From: [REDACTED]
To: [Norfolk Boreas](#)
Cc: [REDACTED]
Subject: Norfolk Boreas Open Floor Hearing - 13 Nov 19
Date: 23 November 2019 16:35:23
Attachments: [PINS Written Response 23 Nov 19.docx](#)

Your Reference: EN010087

**NORFOLK BOREAS PROJECT
WRITTEN REPRESENTATION IN SUPPORT OF ORAL STATEMENT MADE AT OPEN
FLOOR HEARING ON 13 NOV 19**

Hornsea Project Three
Grid Connection and Indicative Route Options

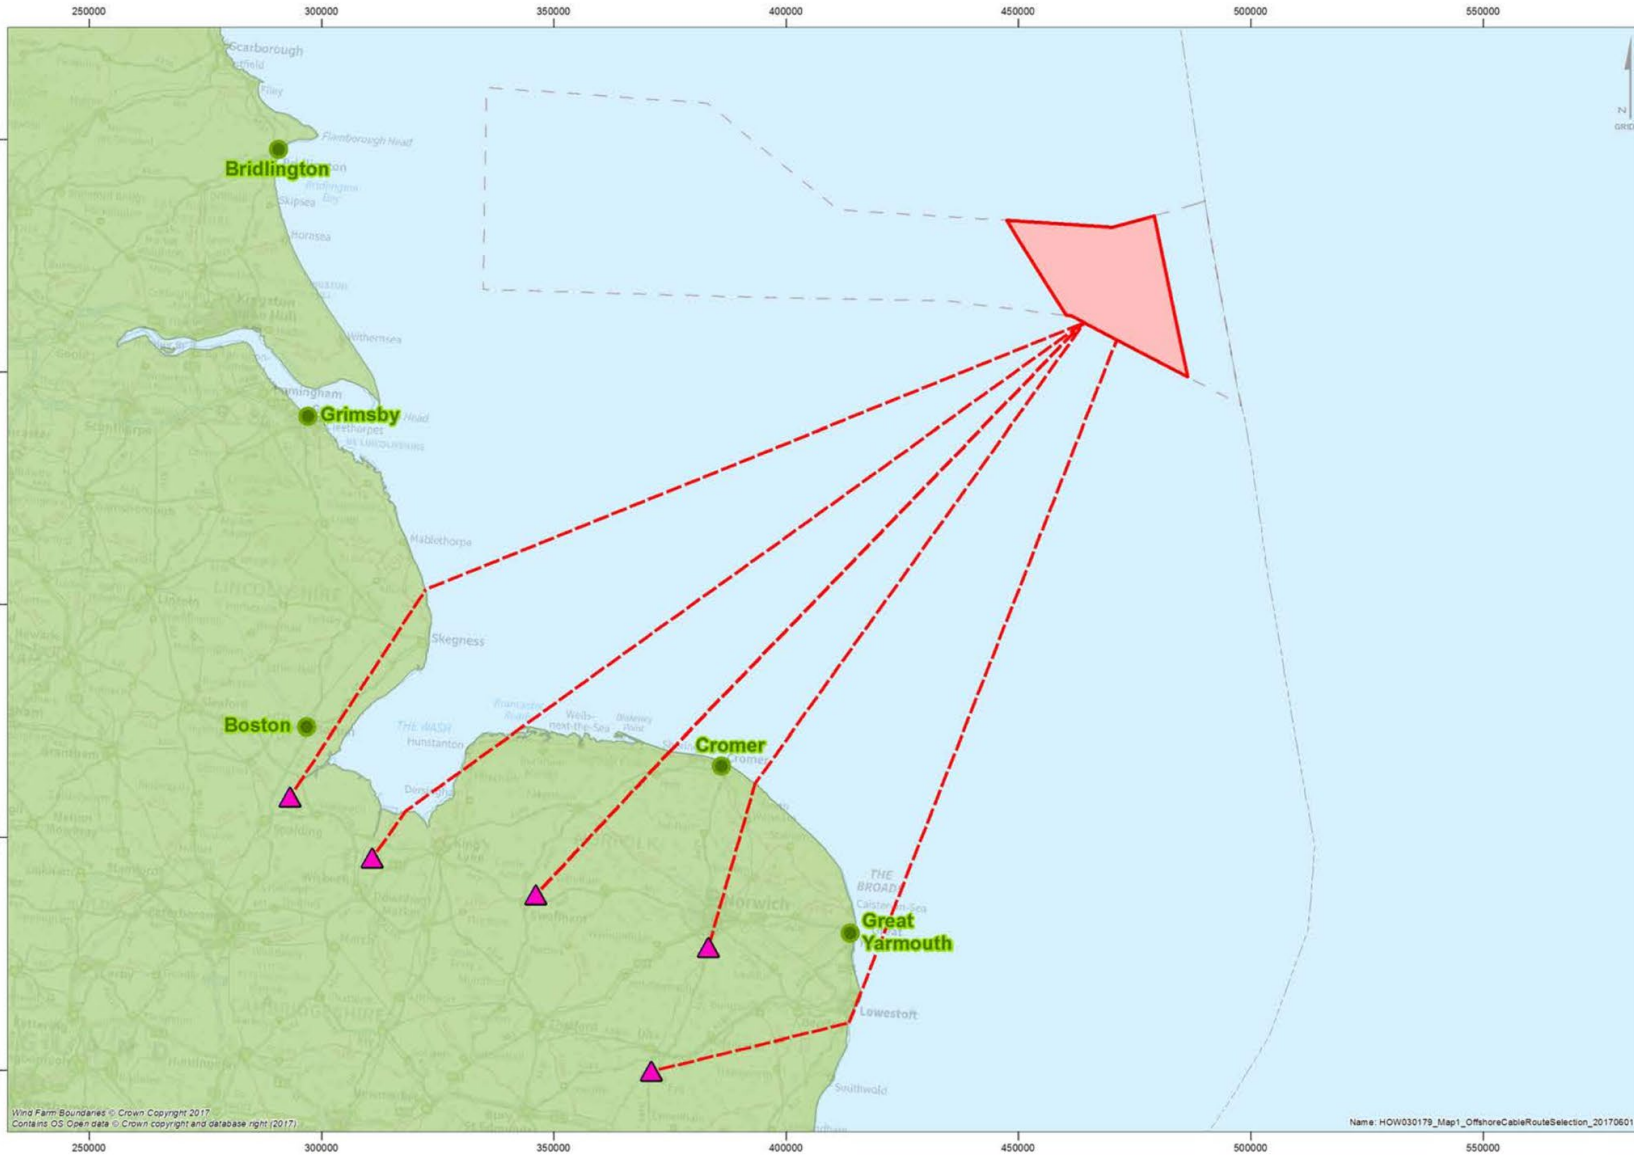
The Hornsea Three Project explored five options: Norwich Main, Walpole, Newton, Bicker Fen and Eye (See attached). Accepting that Necton had been previously offered to Vattenfall, why was Walpole so easily discounted? Dong's Race Bank Project is routed through the Wash to Walpole and sets a precedence for any environmental impact. There is nothing in either the PEIR, or the details provided by yourself, that would discount Walpole as not being more cost effective than Norwich Main. The cable length would be approximately the same when considering the need to route an on-shore cable around Norwich from landfall at Weybourne, and, would be primarily a Marine Cable with approximately a 6 mile on-shore requirement. We contest that the cost of excavating 55km's of land, with a 60m trench, 1.5m deep, as in the current plan, will be significantly more expensive than routing the cables through the Wash to connect at Walpole. We do not accept that this decision was made on comparative costs and believe that there is a different underlying issue which is not being placed for scrutiny in the public consultation process.

We respectfully ask on what criteria was Norwich Main offered by National Grid as the only connection point for the Hornsea Three project?

For the Hornsea Three project, a range of options were jointly considered with DONG Energy, including Walpole amongst others as you point out. Connecting at Walpole would involve a longer cable connection and consenting challenges for DONG Energy, that they are best placed to expand on. A new substation would also be needed somewhere in the vicinity of the existing Walpole substation. We wouldn't be able to simply extend the existing Walpole substation because that would give rise to system issues. Norwich Main was identified as the preferred connection option by DONG Energy and National Grid as it presented the shortest overall cable route and the lowest environmental risk.

AC magnetic field calculations for HVAC cable crossings

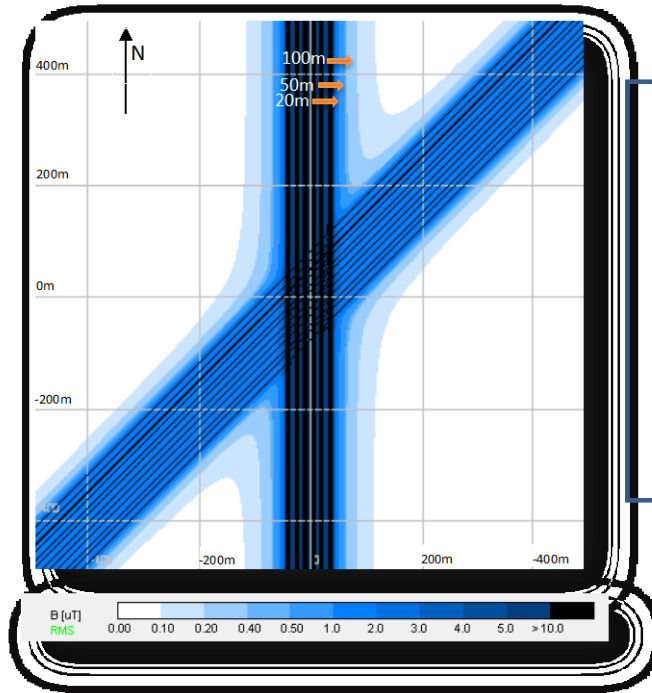
We have been supplied with a theoretical assessment of the EMFs at the crossing point for HVAC v HVAC and HVDC v HVDC (Attachment 3). However, now Vattenfall have elected to utilise HVDC, there are two further options which need to be modelled, that is: HVAC, 6 Circuits 'On Top' of HVDC 4 Circuits, and, HVAC 6 circuits 'On Bottom' of HVDC 4 Circuits. Both of the recent representations from Ørsted and Vattenfall for Hornsea Three and Norfolk Vanguard respectively, claimed that HVDC fields do not interact with the HVAC fields; these were absolutely false representations. However, there is now an opportunity with Norfolk Boreas to set the record straight and provide the facts and calculations required of a full and in-depth consultation. We ask the Inspectorate to make sure we are provided with the full picture for all the possible combinations of cables at the crossing point.

Also, from basic physics, placing a large conductor with a static magnetic field in an oscillating field will induce currents and have an effect on the conductor. There will be localised heating and the position of the HVAC cables, above or below the HVDC cables, will be significant and should be modelled accordingly. There are many questions regarding Public Health and the mix of HVDC with HVAC as can be read about in References 3, 4 and 5.

Worst-case calculated magnetic fields from AC circuits: The two cable routes modelled include 6 circuits running in a North-south direction with each circuit rated at 1620A; and 12 circuits which run underneath in a North East-South West direction with 900A rated circuits. Coloured bands represent magnetic field. Each square represents 200m distance. The orange arrows indicate the distance perpendicular from the outer cables that correspond to the table above.

The maximum calculated magnetic fields at various distances from the outer cable are included in the table and demonstrate that all AC magnetic fields are below the UK exposure limits
